TRANS/WP.29/GRSP/2001/7 14 February 2001

World Forum for Harmonization of Vehicle Regulations (WP.29)

PROPOSAL FOR DRAFT AMENDMENTS TO REGULATION No. 94

(Frontal collision protection)

Paragraph 6.2.1., amend to read:

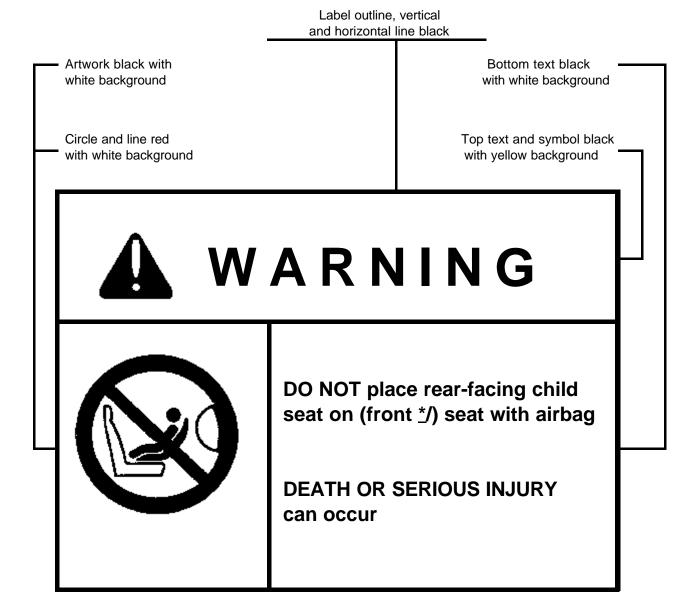
"6.2.1. As a minimum, this information shall consist of a pictogram and text warning as indicated below. The text shall be in at least one language of the country in which the vehicle is sold. The information must be durably affixed to the vehicle in a way that will ensure that the warning remains present and legible for the life of the vehicle and cannot easily be removed without the use of tools.

*/ Alter according to which seat the warning applies.

The overall dimensions shall be 130 mm x 60 mm, as a minimum."

The new warning proposed replaces the current figure in paragraph 6.2.1. of Regulation No. 94 showing the ACEA pictogram. It is based on the Figure from paragraph 4.5. of Supplement 2 to the 03 series of amendments to Regulation No. 44. This paragraph describes the label required to be placed in the immediate area where the child's head rests within a rearward facing child restraint.
